Amendments to document TRANS-WP29-GRRF-58-inf12e resulting from discussions at the 11th October 2005 meeting in London and addition work subsequent to the meeting to bring the second (trailer) part of the document in line with the first (motor vehicle) part and add in document EVSC05-35 Rev 1.

Proposed amendments to ECE Regulation No. 13,

A. PROPOSAL (Provisions for vehicle stability control systems)

~~Regulation No. 13 Appendix 1~~
~~Example of the Simulator~~
~~(see item 5.2.1.31.3 of this Regulation)~~

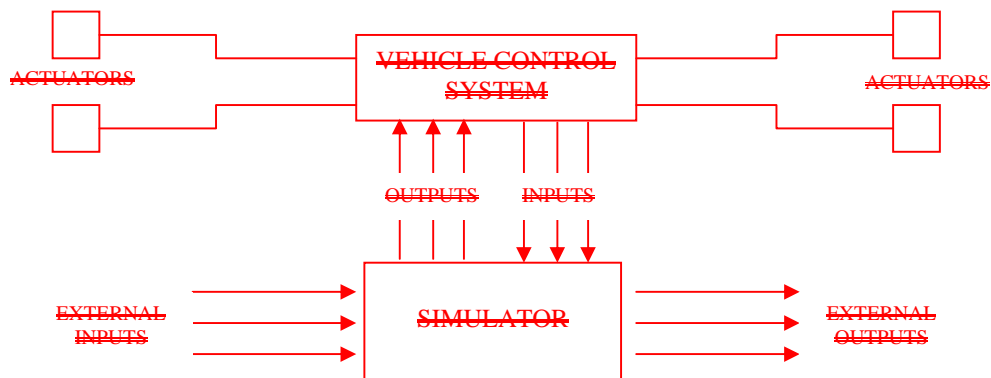
~~1. The simulator~~

~~This Appendix defines an example of a simulator that may be used to demonstrate the functionality of the vehicle equipped with a vehicle stability function as defined in item 2.3.2 of this Regulation.~~

~~1.1 The simulator shall produce the required signals compatible with the control system to be evaluated and shall also react to the response of the control system to those signals so that it is possible to demonstrate the affect of the control on the vehicle for which approval is required.~~

~~1.2 The following diagram provides an example of the layout of the simulator:~~

~~1.3. The simulator shall at least include the following parameters:~~

Add new Appendix 1 to read:

Appendix 1

DYNAMIC STABILITY SIMULATION
